PLANNING AND ZONING COMMISSION

Monday, June 27, 2016

<p>SUBJECT: Consider making a recommendation on the Preliminary and Final Plat for Elmerodo Estates Plat 4, subdividing 13.53 acres into one lot, one outlot, and one street lot. The property is located west of NW 100th Street and approximately 275 feet south of the Johnston city limits (PZ Case 16-20).</p>	
<p>SYNOPSIS:</p>	<p>The applicant, Mark Shryock, wishes to subdivide the subject property into one lot, one outlot, and one street lot. Proposed Lot 1 would contain the existing home on the property. Proposed Outlot V is intended for future development. Proposed Lot ‘A’ would be deeded to the City for street right of way.</p>
<p>RECOMMENDATION:</p>	<p>Staff recommends approval and provides the following motion for the commission’s consideration:</p> <p>The Planning & Zoning Commission recommends approval of PZ Case No. 16-20, the Preliminary and Final Plats for Elmerodo Estates Plat 4, with the following conditions:</p> <ol style="list-style-type: none"> 1. The project shall be in conformance and in accordance with the requirements, standards and regulations of the City of Johnston, and any other requirement of state or fede

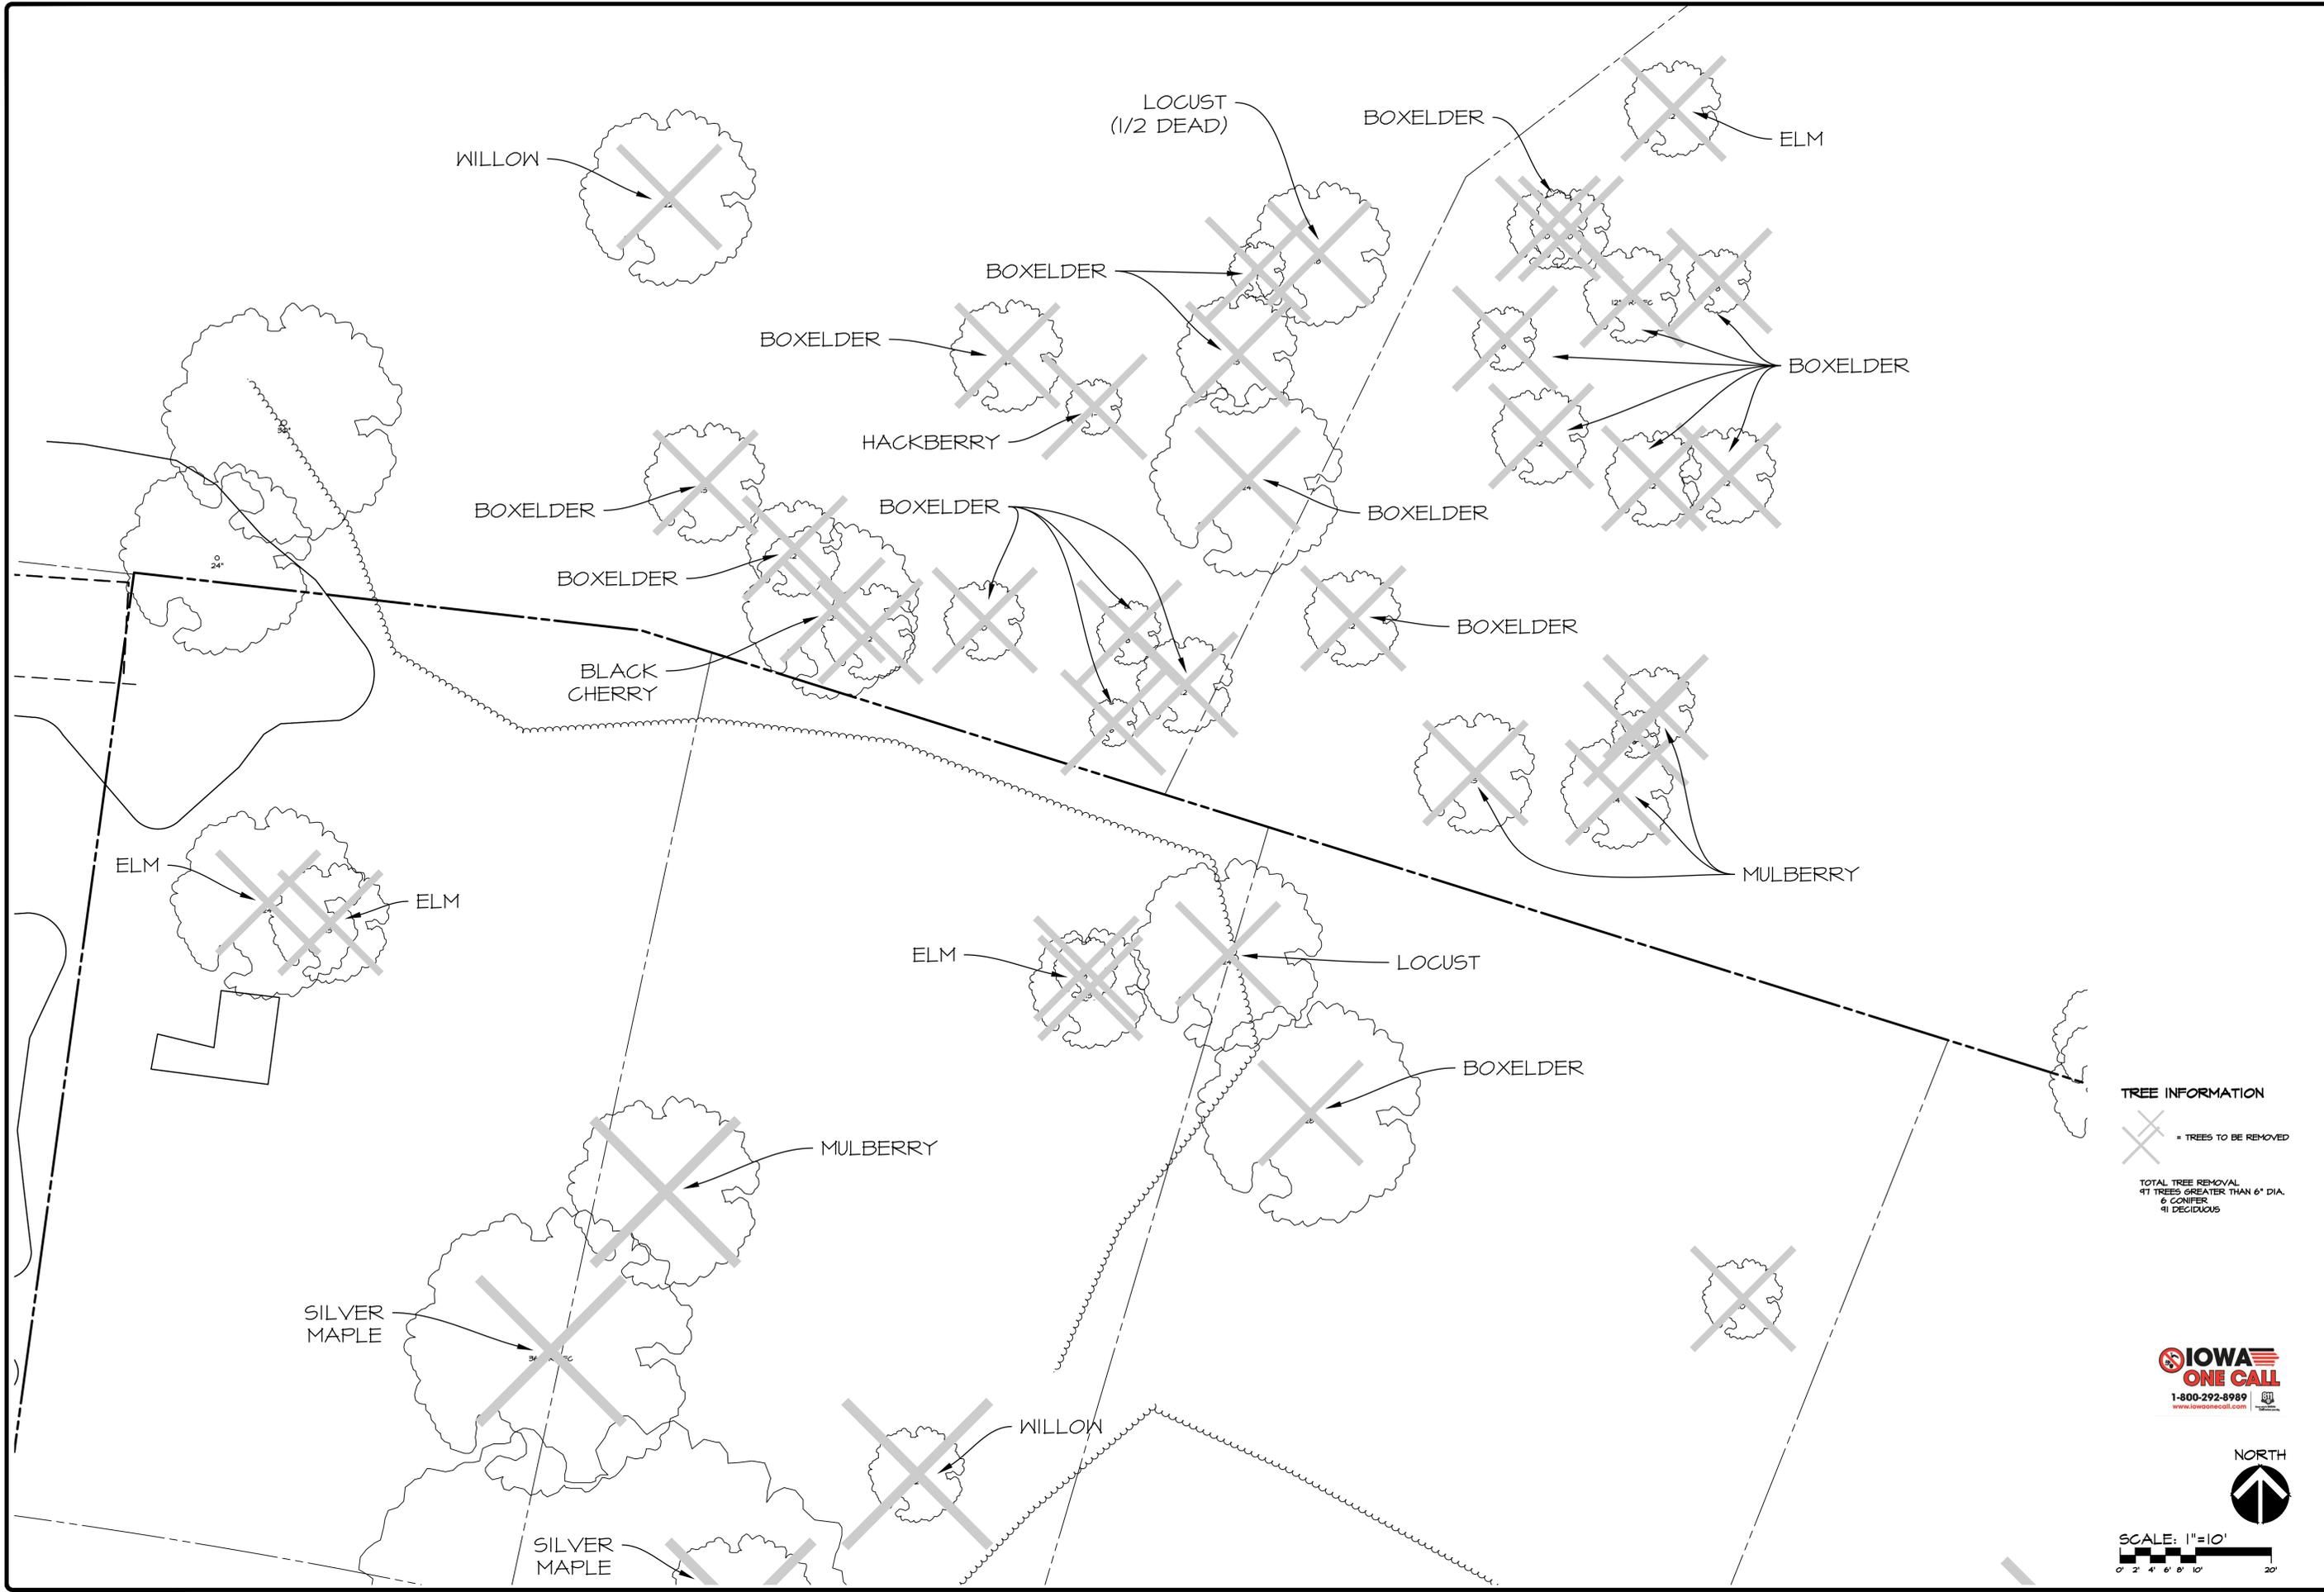
1. Label front yard setback
2. Generally the plat contains too much information to be adequately viewed on two pages, additional pages are suggested. Please show utilities on their own sheet. Show existing condition on own sheet
3. Indicate fire hydrant coverage area spaced a minimum of 600' in residential areas (300' coverage radius).
4. Include an inventory of all trees greater than 6 inches in diameter to be removed.
5. Chapter 180.43 of our code of ordinances requires dedication of 5 acres of public parkland for each 1,000 residents added to the community. The amount of parkland necessary is computer using the following formula:

1. All existing easements should include the book and page number.
2. Overland flowage and storm sewer easements should be provided for all Bio-Cells and Bio-Swales.
3. The location of CBUs must be shown on the preliminary plat. The location of CBUs must be reviewed/approved by the Post Office. More than one cluster box unit may be necessary, verify with Post Office. All associated pavement/sidewalks shall be constructed prior to the acceptance of the public improvements. Please see Chapter 142.05 City of Johnston Code of Ordinances regarding the location of CBU's in the public right of way. Also attached are regulations provided by the Post Office. Contact Postmaster Joleen Bolger at 334-0216 to discuss location of CBU's prior to resubmittal of the Preliminary Plat or through email at Joleen.K.Bolger@usps.gov.

2. Intensity values used for the 5-year appear to be 2-year values. Revise intake calculations accordingly.
3. 100-year undetained offsite bypass from DA 12 & DA 25 is not accounted for in the allowable release rate. Including DA 12(3.22 cfs) and DA 25(1.88 CFS), the new allowable release rate should be 33.24 cfs (38.34-5.10 cfs)
4. Include city of Johnston storm water summary sheet.

3. **The Preliminary Plat and Stormwater Management Report shall be amended to address the following items:**
 - a. Address all outstanding comments from Foth’s comment letter dated, June 22, 2016.
